PRIVATE LINE SERVICE TERMINATIONS
STATION ENGINEERING INFORMATION
STATION EQUIPMENT (DATA-VOICEBAND)

1.001 This addendum supplements Section 812-002-230, Issue 3.

1.002 This addendum is reissued to delete a Caution and add a Note in Fig. 11, 12, and 13.

Fig. 11—Diagram for Full Data-Alternate Voice at Station

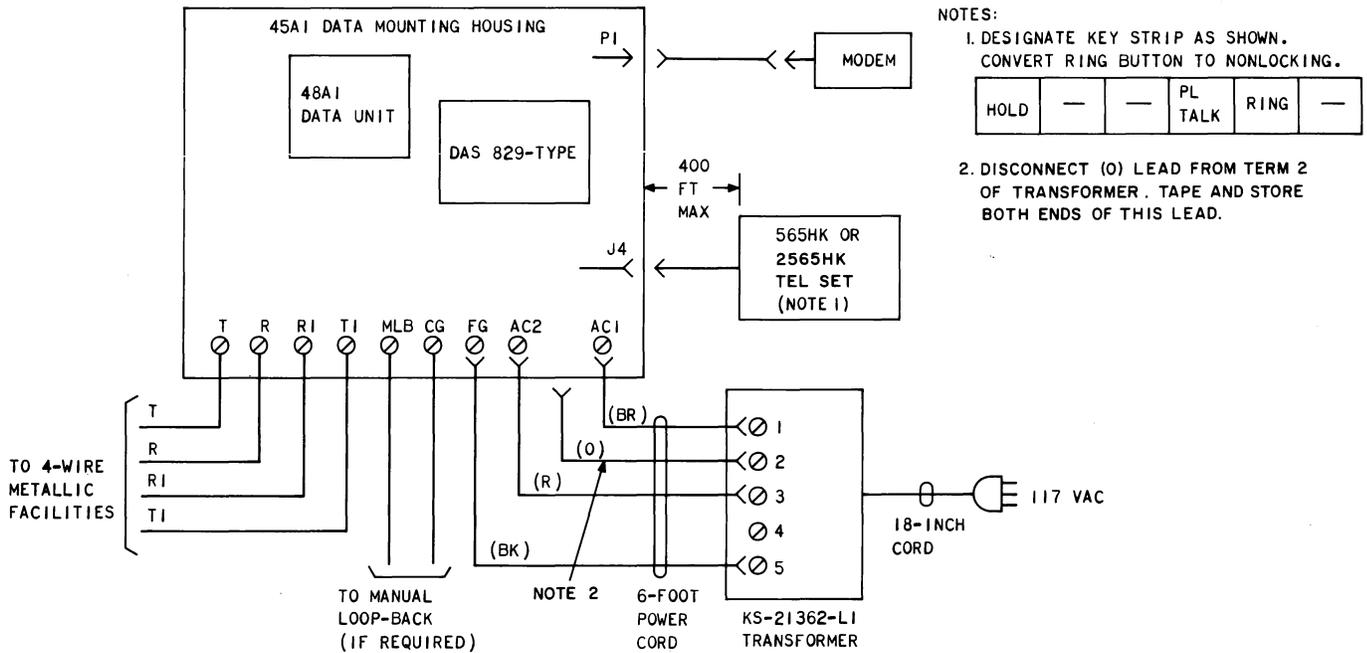
2.001 On Pages 34 and 35, Fig. 11, 12, and 13, delete Caution and add Note as follows:
